CROSSROADS AT MEADOWBROOK-MIXED USE PRELIMINARY PLAN

PCD FILE NO: SP-20-011

prelim plan V_4 PLANNING AND SOME ENG.pdf Markup Summary 9-2-2021

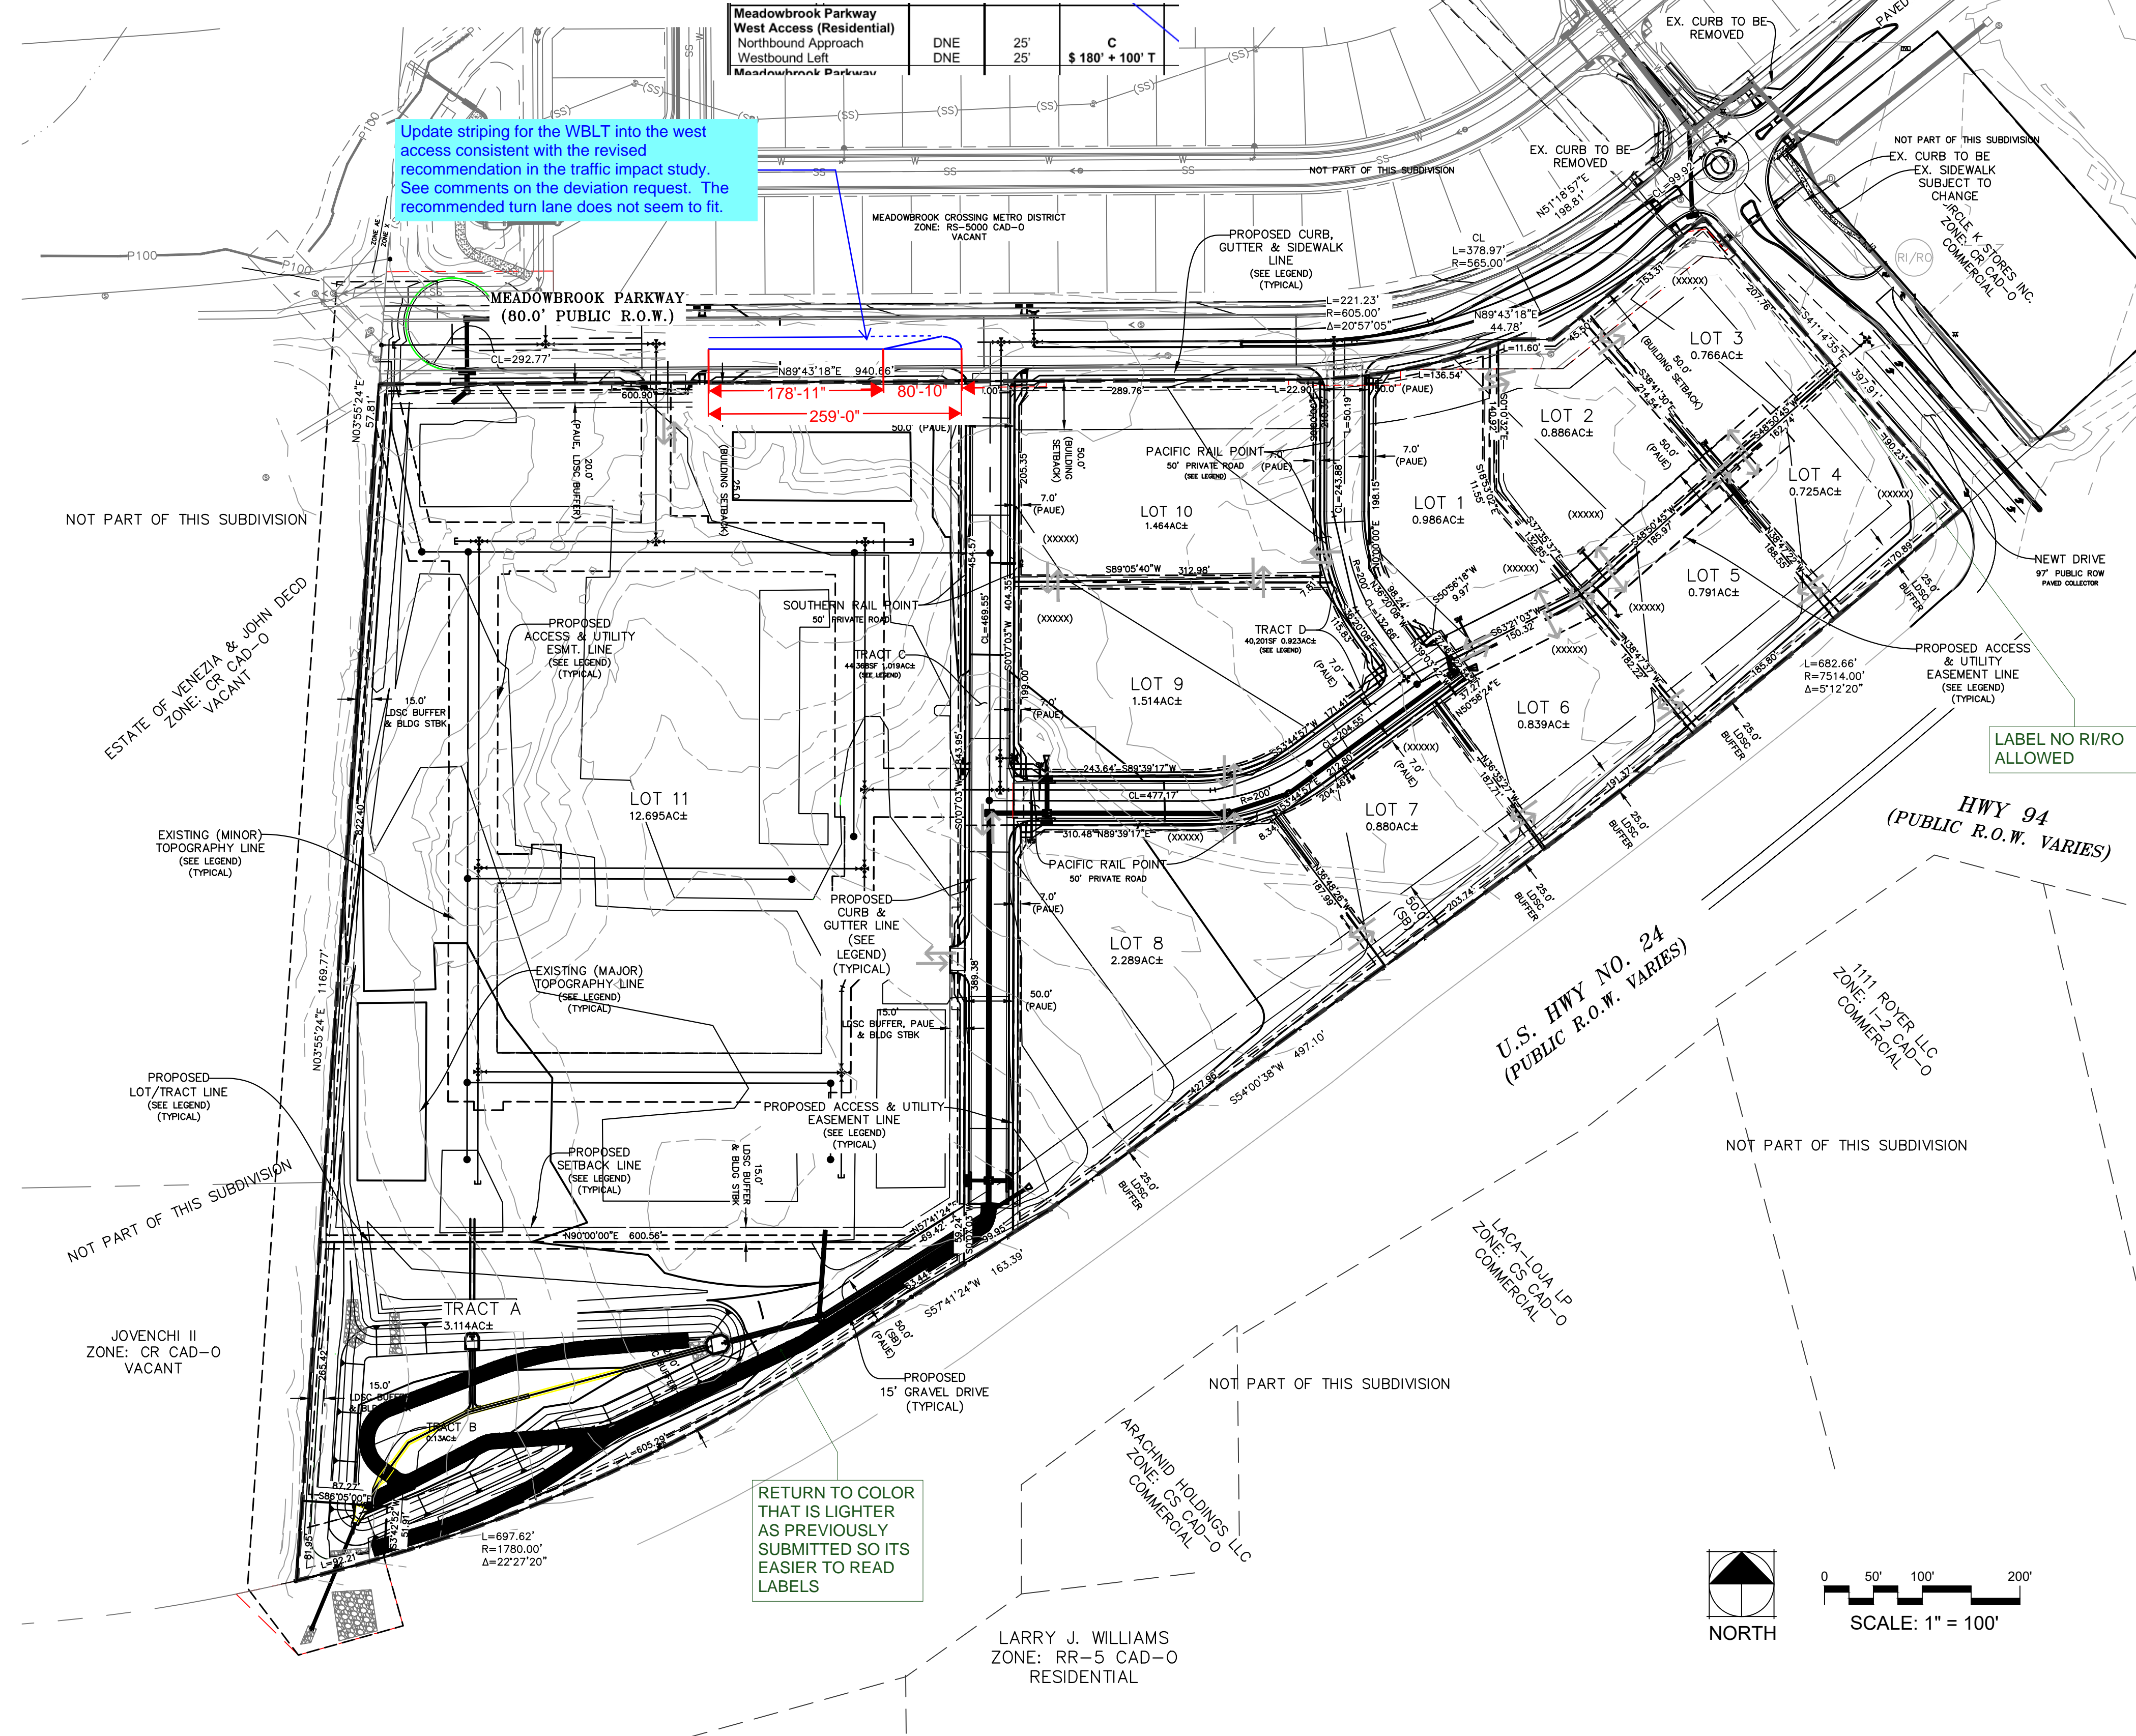
Update striping for the WBLT into the west access consistent with the revised recommendation in the traffic impact study.
See comments on the deviation request. The recommended turn lane does not seem to fit.

RETURN TO COLOR THAT IS LIGHTER AS PREVIOUSLY SUBMITTED SO ITS EASIER TO READ LABELS

LABEL NO RI/RO ALLOWED

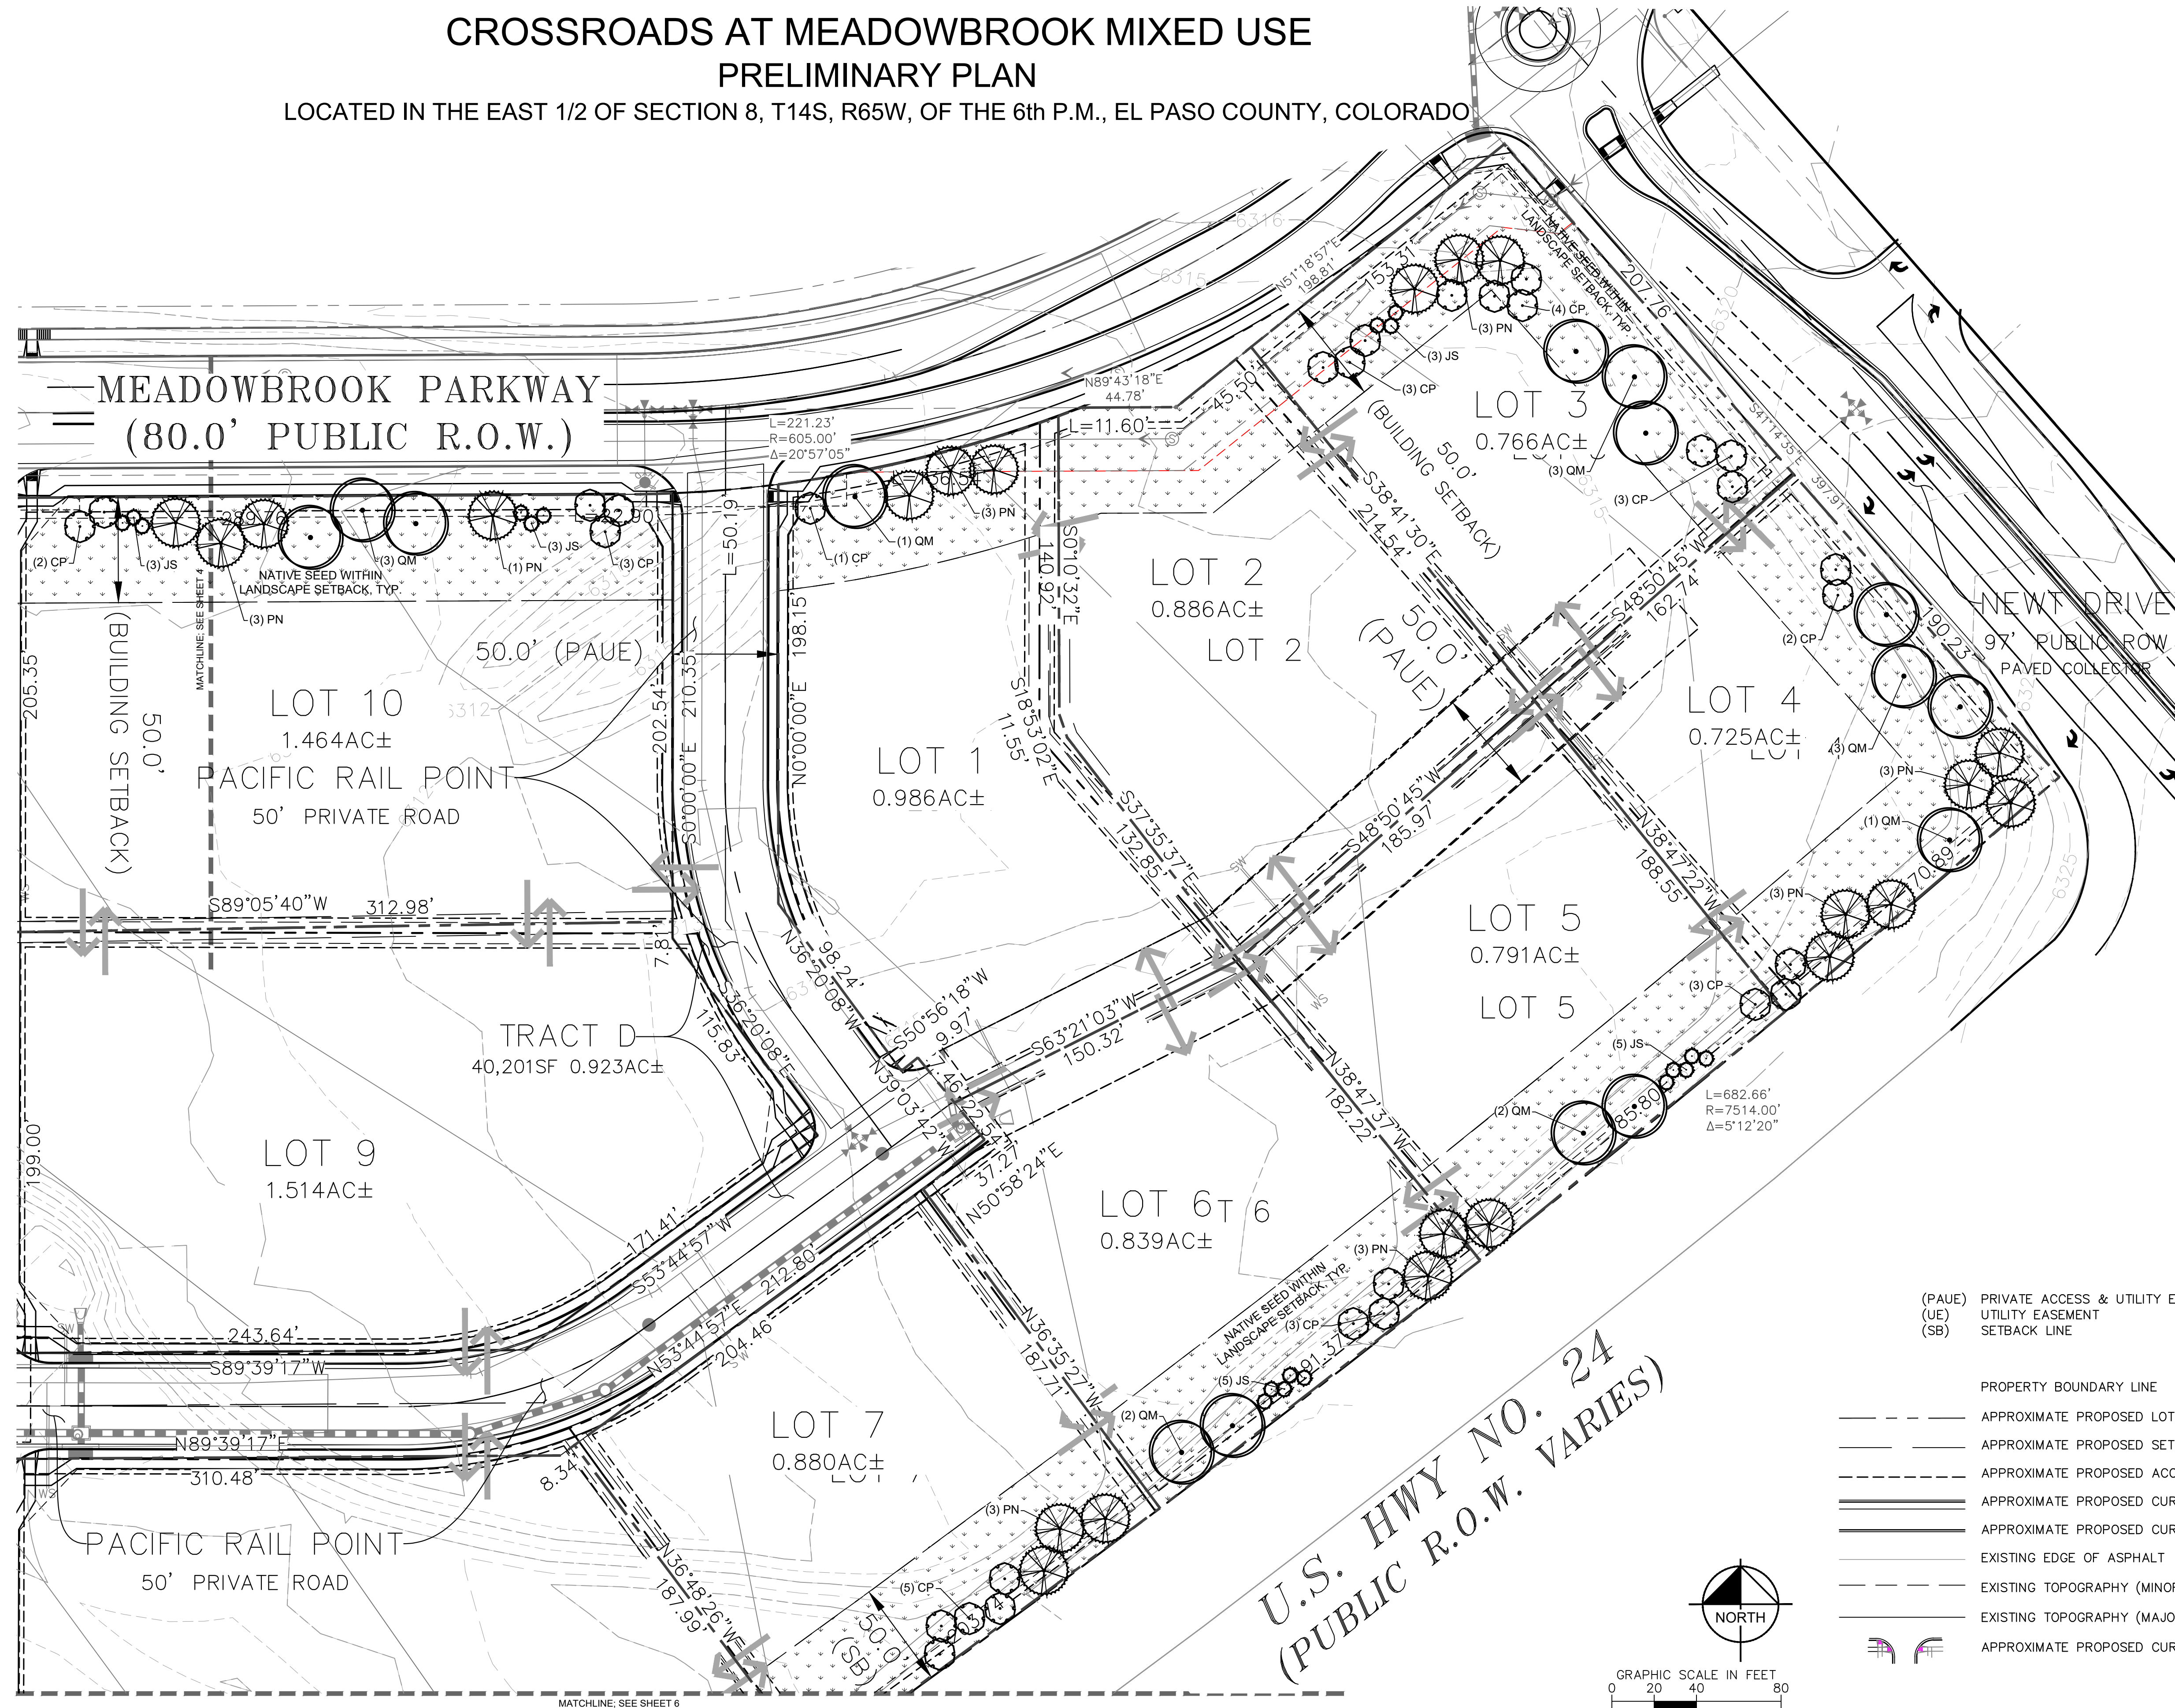
Revise to 12' lane width per ECM Table 2-7

fix line weight to text is legible. Typical for all.

remove the trees within the ROW.
Typical for all cross sections.

Is this correct that the the development will convert Highway 24 to curb and gutter type of cross section? Leave as shown if true or you may want to add a footnote if the final cross section for the CDOT improvements is still being coordinated/finalized with CDOT.

Update dimensions from varies to the widths per criteria

See ECM 2.5.6.H for designing the raised median for left turn lanes.

If the left turn lane for the middle access extends through the RIRO intersection a deviation request is likely required reducing the landscape stripe in order to make room for the 6' raised median divider.

Unresolved. Update the street configuration per the redline markup. Double check that the sum total of all the widths equal 80'. Update the site plan layout to match the dimensions on the cross section.

Add the 6' shoulder

Add the 6' shoulder

Reduce landscape strip to 5'

Reduce landscape strip to 5'

Transition taper to occur at this location from cross section C-1 to C-2. Per ECM Table 2-29 the taper ratio shall be 20:1

adjust the C&G dimension line to back of curb.

NO LANDSCAPE MAY BE IN THE PUBLIC ROW
